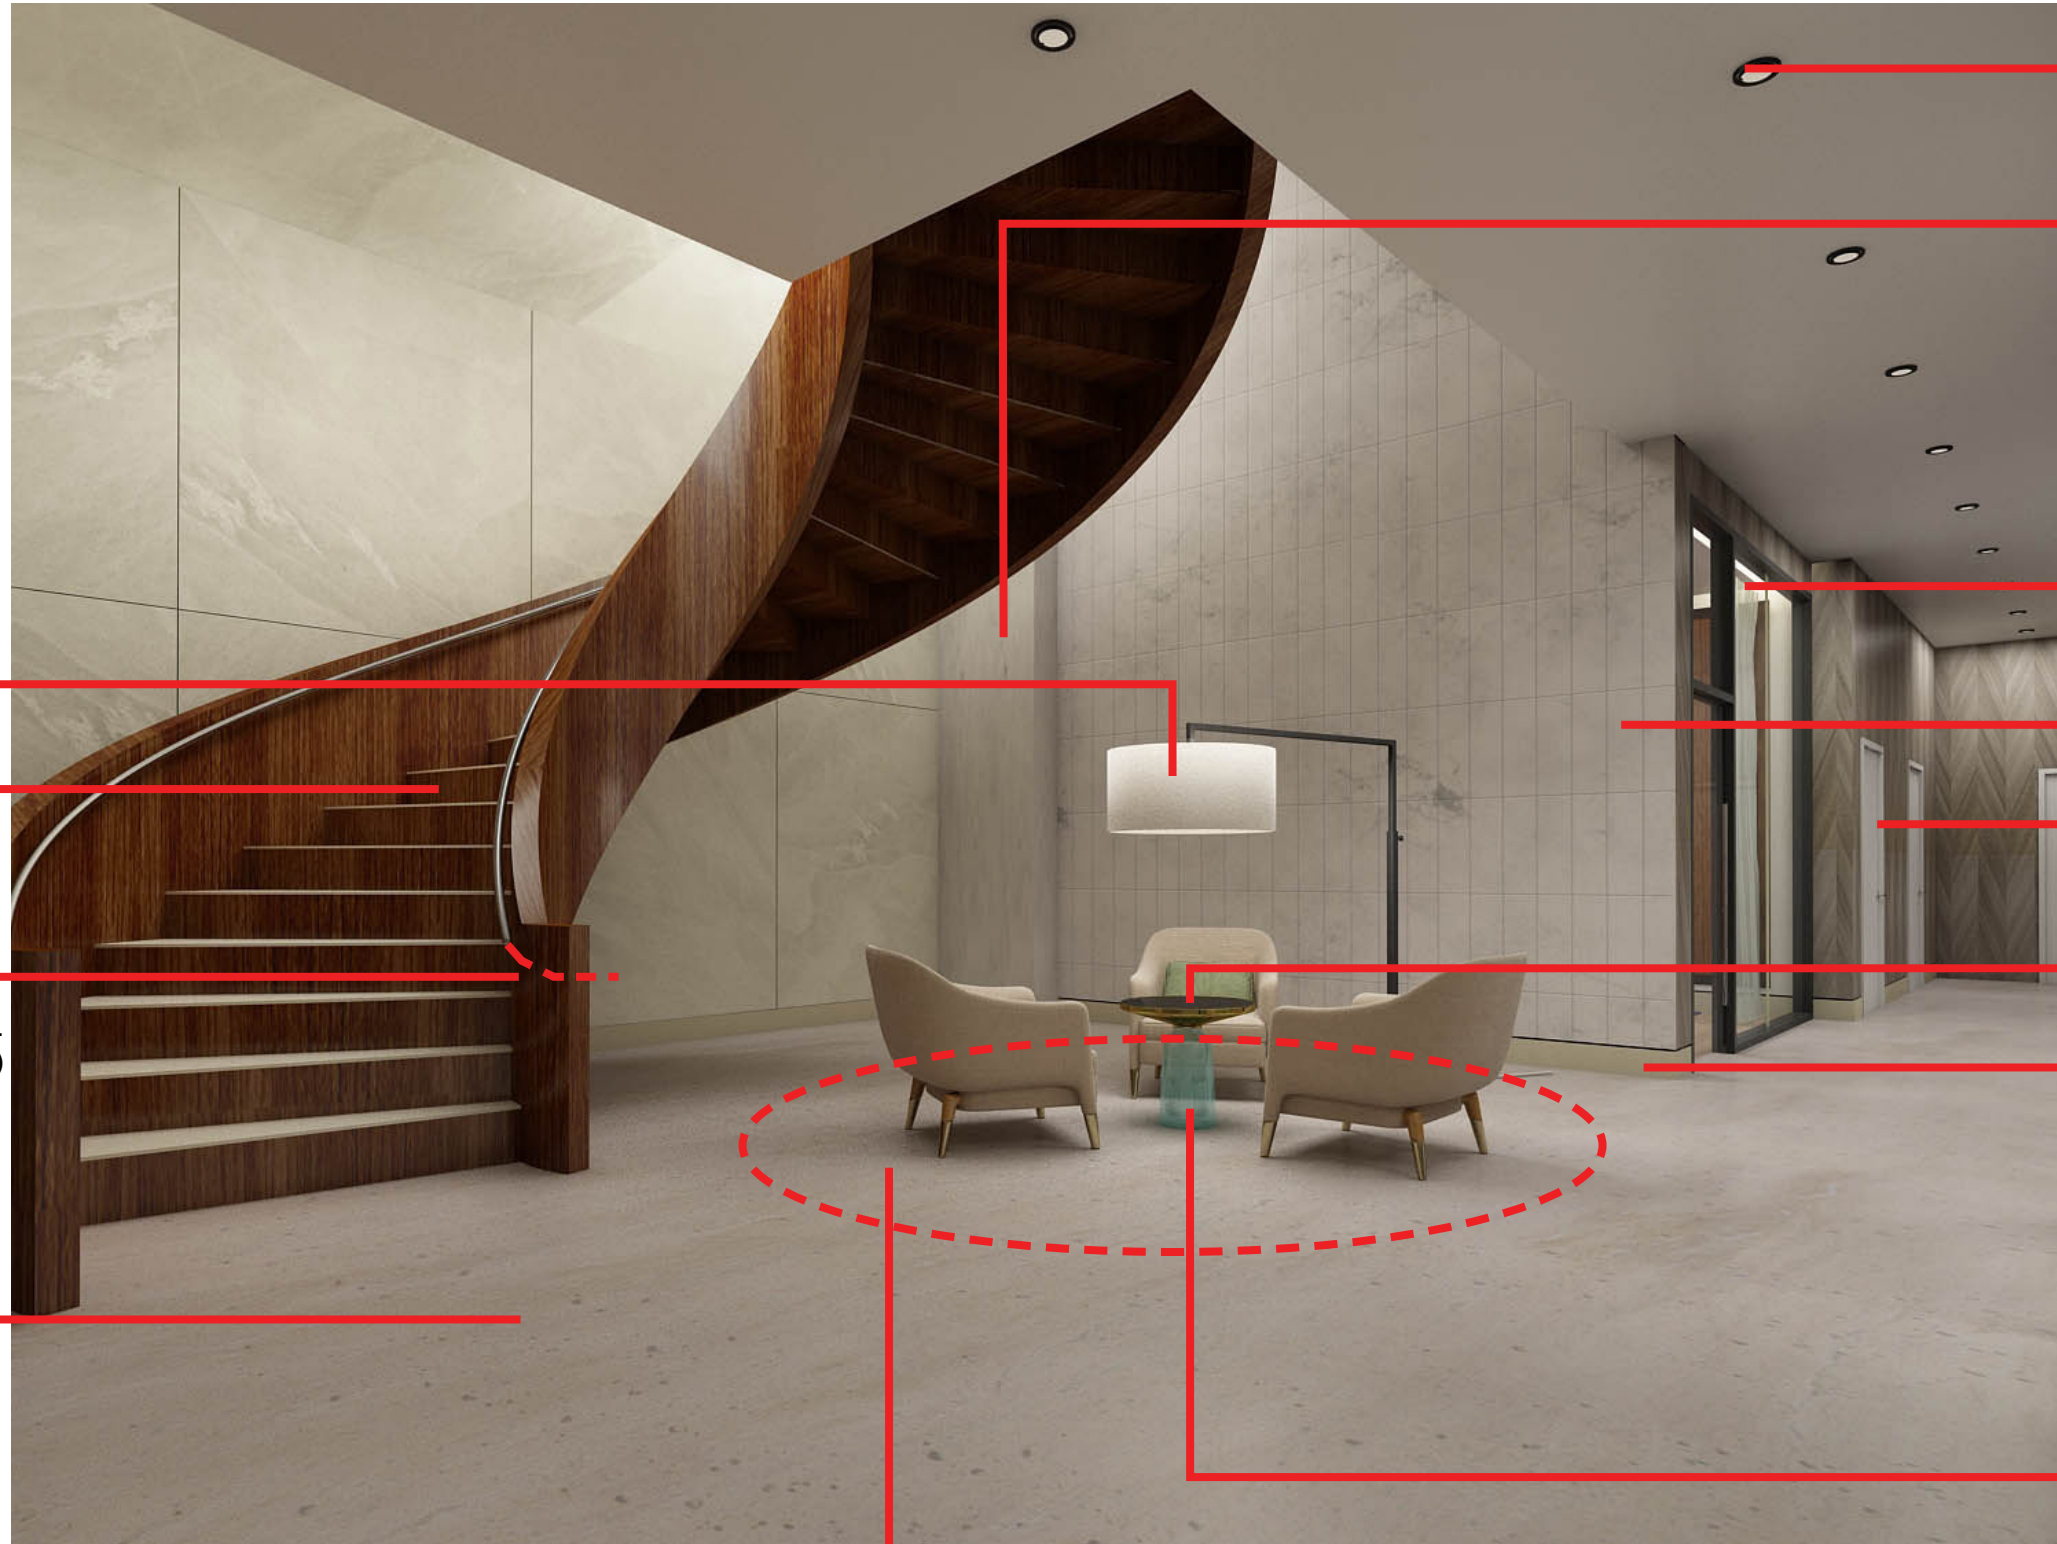
*IMAGE FOR REFERENCE ONLY
 REPLACE FLOOR LAMP WITH: F.48 (BLACK SHADE & METAL)

CREATE DEEPER KICKS IN RISERS OF STAIRS; PUSH BACK 25MM FROM EDGE OF STONE TREADS

EXTEND HAND RAIL GUIDES, MINIMUM 305MM FROM END OF STAIR TREAD REQUIRED BY CODE. (PARALLEL WITH FINISHED FLOOR)

FLOOR TILE PATTERN IS NOT SHOWN, REFER TO FLOOR FINISH PLAN. (3 DIFFERENT TILE SIZES)

RECESSED LIGHTS ARE INCORRECT, REFER TO LIGHTING SPECIFICATION (L.2)

REMOVE COLUMN HERE, REFER TO PLAN FOR REFERENCE.

EXTEND DRAPERY UP, LEAVE NO GAP. CONCEAL WOOD PANEL BEYOND WITH DRAPERY
 WALL TILE TO BE 3 - DIMENSIONAL

DOORS & FRAMES TO BE PAINTED PT.2 (SAME AS BASEBOARD)
 GROUPING TO BE PUSHED BACK TOWARDS FAR RIGHT CORNER(REFER TO FURNITURE PLAN)

BASEBOARD PAINTED PT.2 - STONE HARBOUR, SHOULD LOOK LESS BEIGE
<http://www.benjaminmoore.com/en-ca/paint-color/stone-harbor>

COFFEE TABLE SIZE ENLARGED. REFER TO F.46 FOR SPECIFICATION.

ADD CIRCULAR AREA CARPET; CENTRE TO FURNITURE GROUPING. REFER TO F.47 & FURNITURE PLAN.

CROP CARPET TO CIRCLE; 1800MM DIAMETER

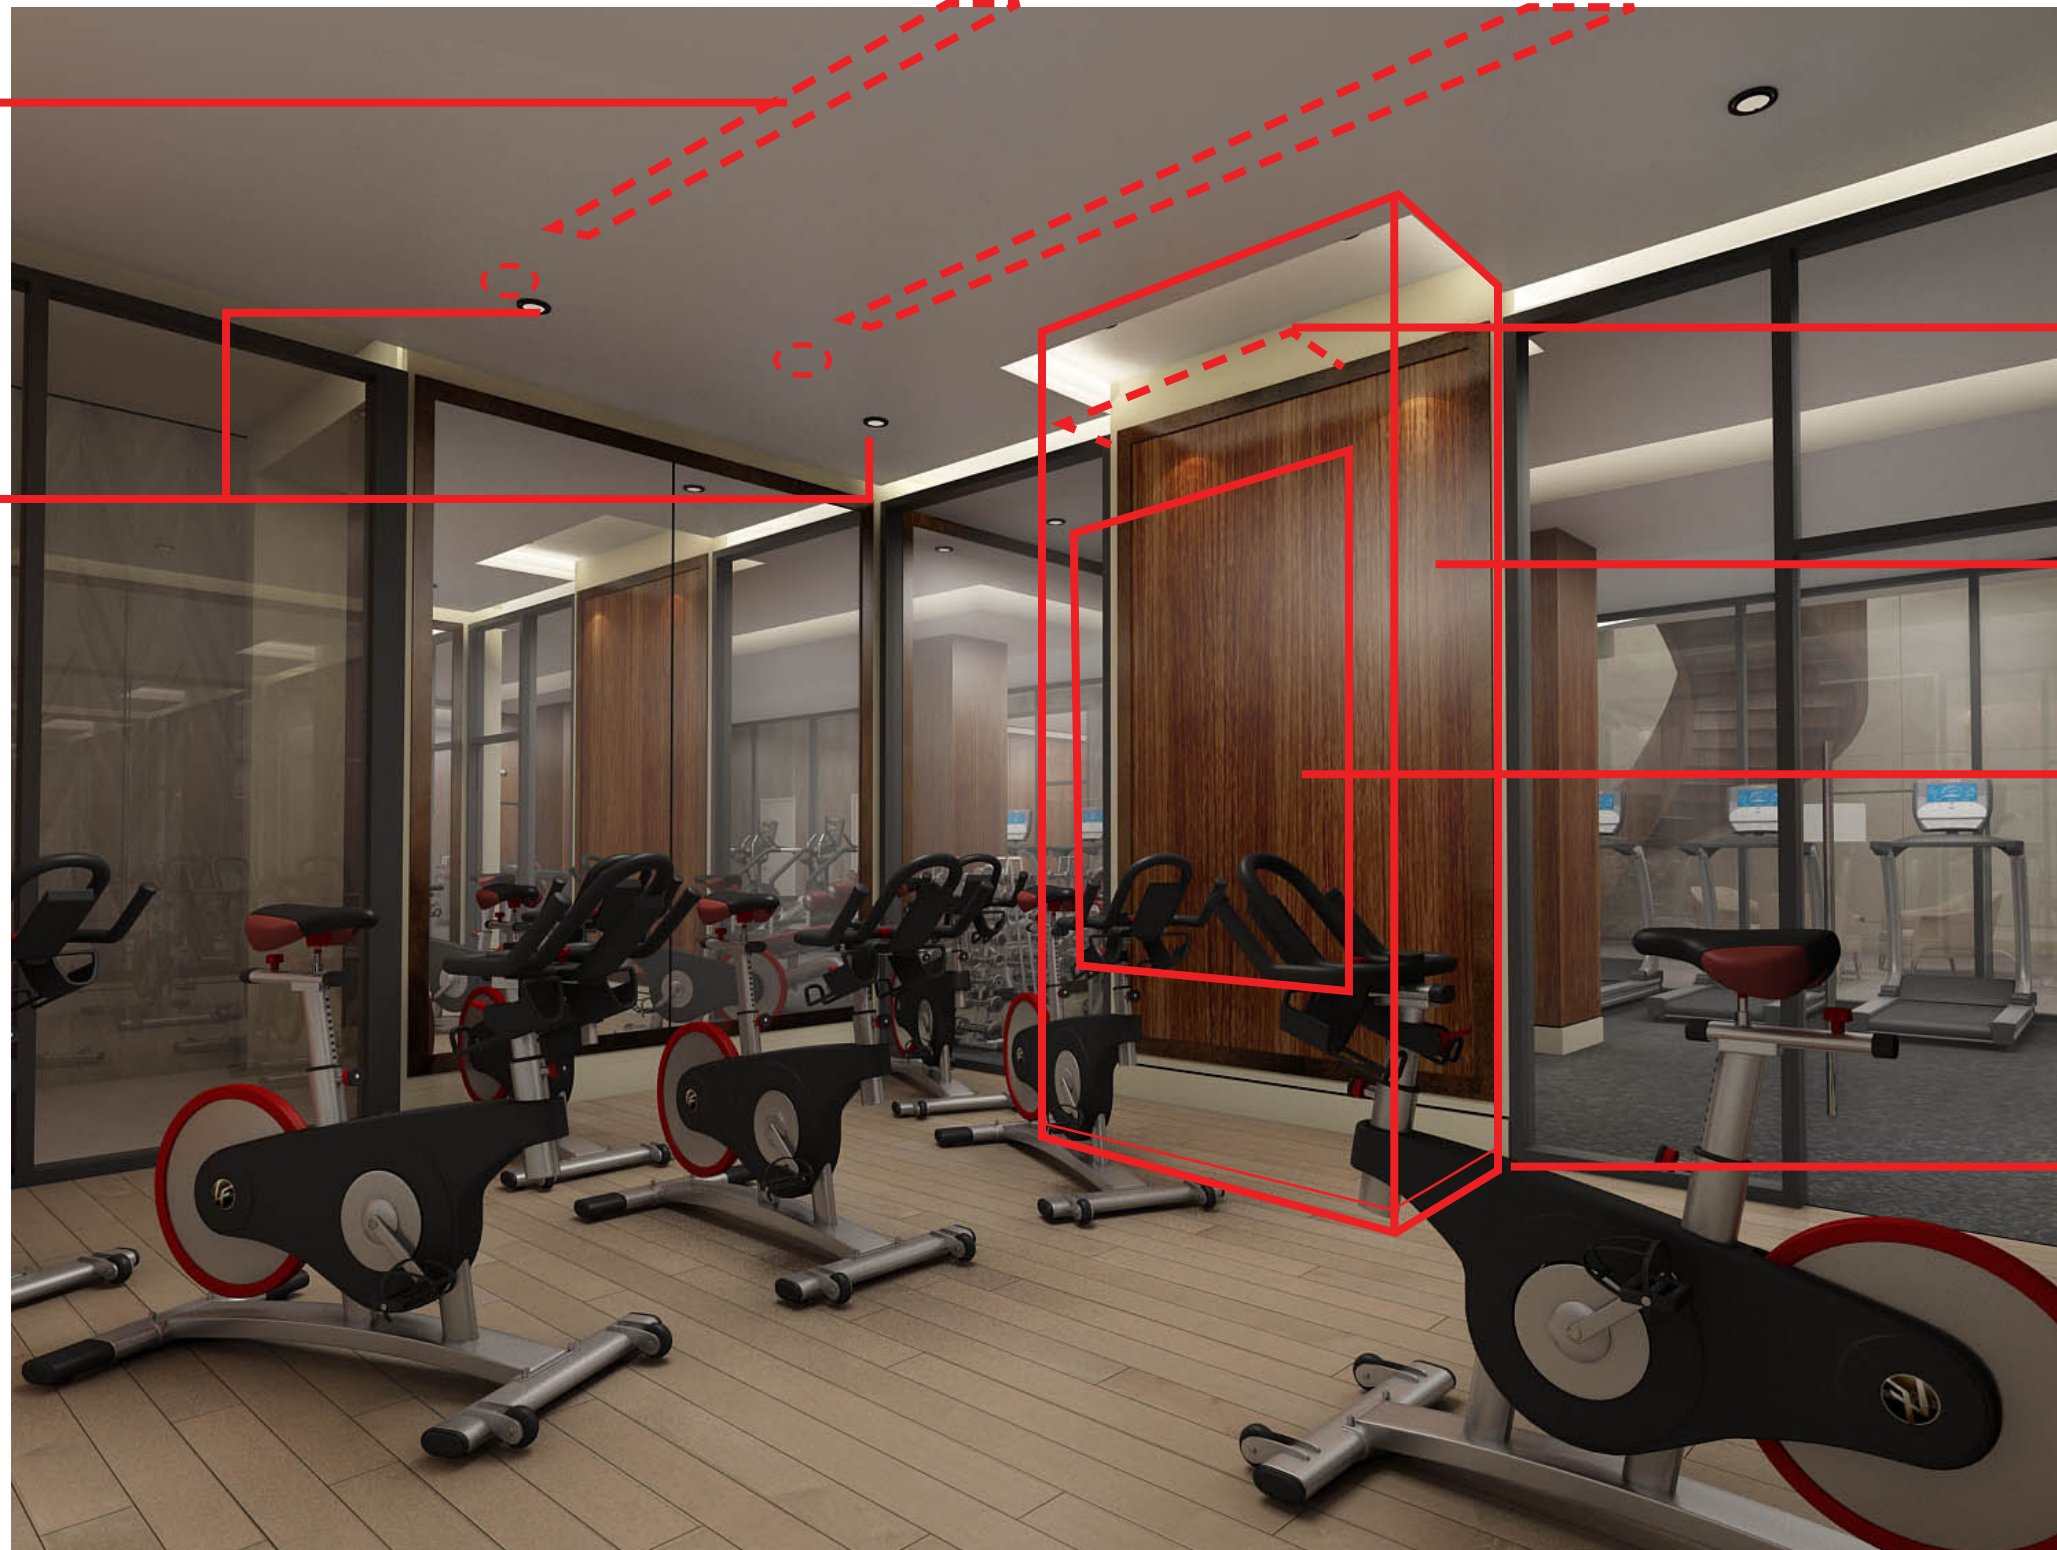
PICTURE LIGHT HERE (L.14)

*IMAGE FOR REFERENCE ONLY
FURRED OUT WALL HERE - WOOD PANEL ALONG SIDES. REFER TO PLAN

BLACK WOOD FRAMED ARTWORK CENTRED TO WOOD PANEL (ART.7)

REDUCE BASEBOARD TO 2", KEEP BLACK REVEAL. REPLACE PAINT FINISH WITH PT.4 (GRAY)

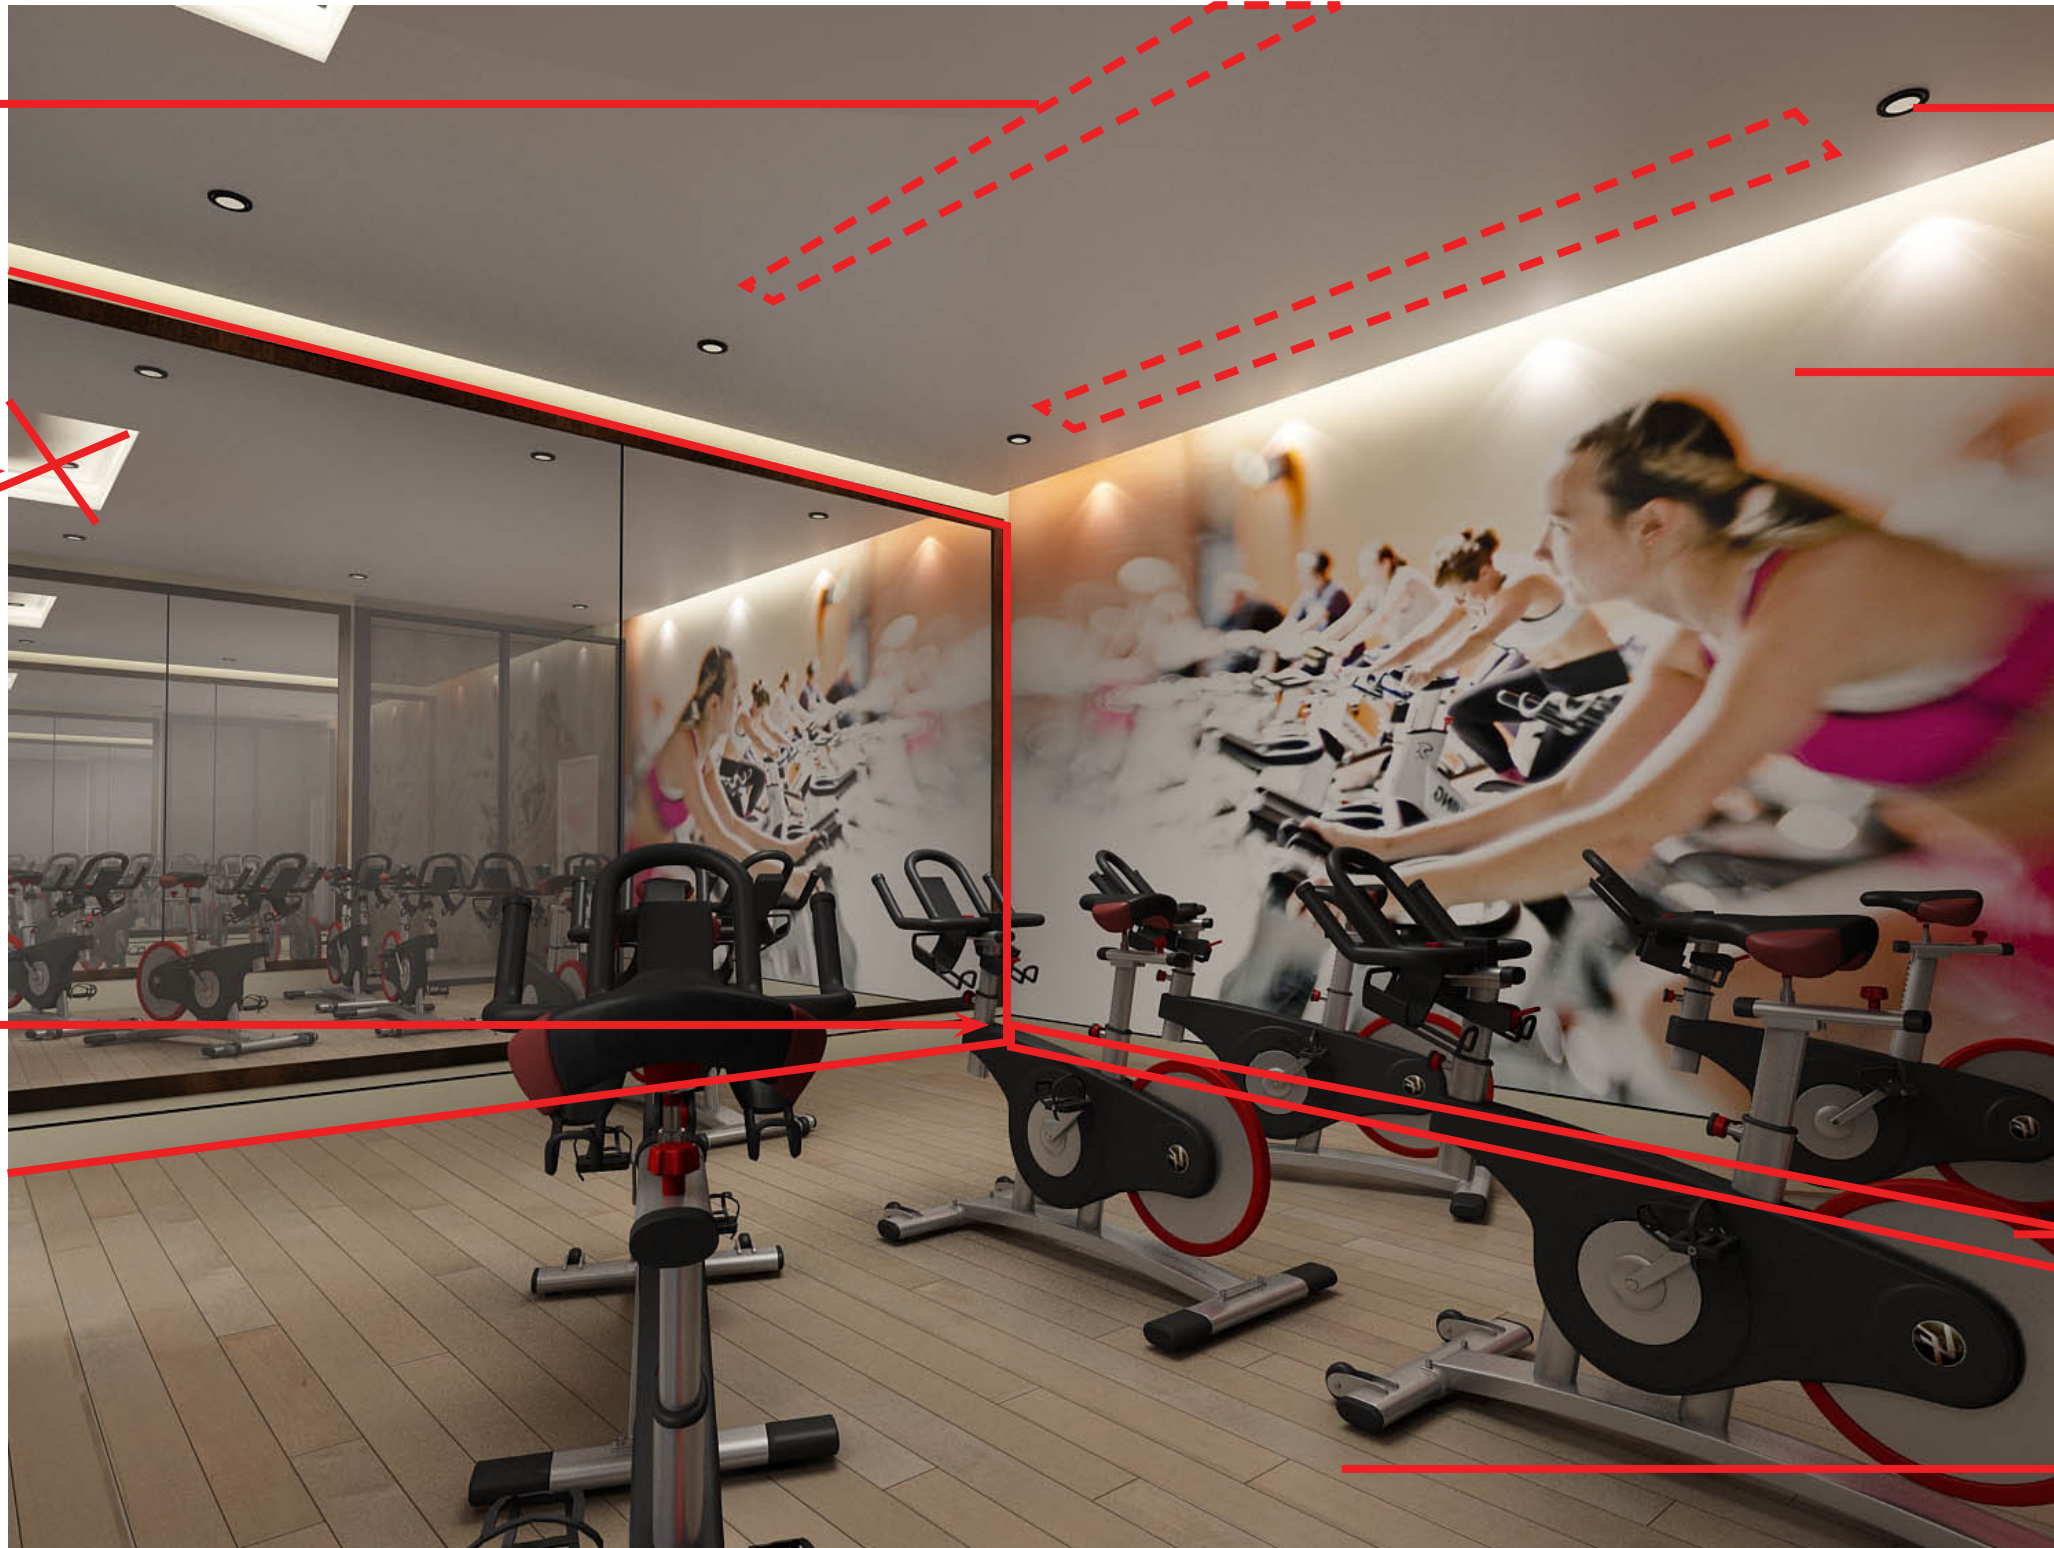
REMOVE COVE

EXTEND MIRROR FRAME TO CONCEAL PAINT FINISH; EXTEND BOTTOM OF FRAME TO FINISHED FLOOR.

RECESSED GENERAL LIGHTING IS INCORRECT, REFER TO LIGHTING SPECIFICATION. (L.2)

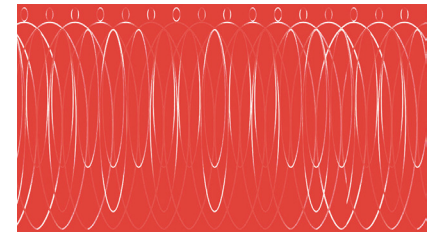
WALL COVERING IS INCORRECT, REFER TO WC.3. CUSTOM COLOUR TO MATCH EQUIPMENT

PANTONE COLOUR REF:
COLOUR BRIDGE COATED
1795C
R 210 G 38 B 48
HTML D22630
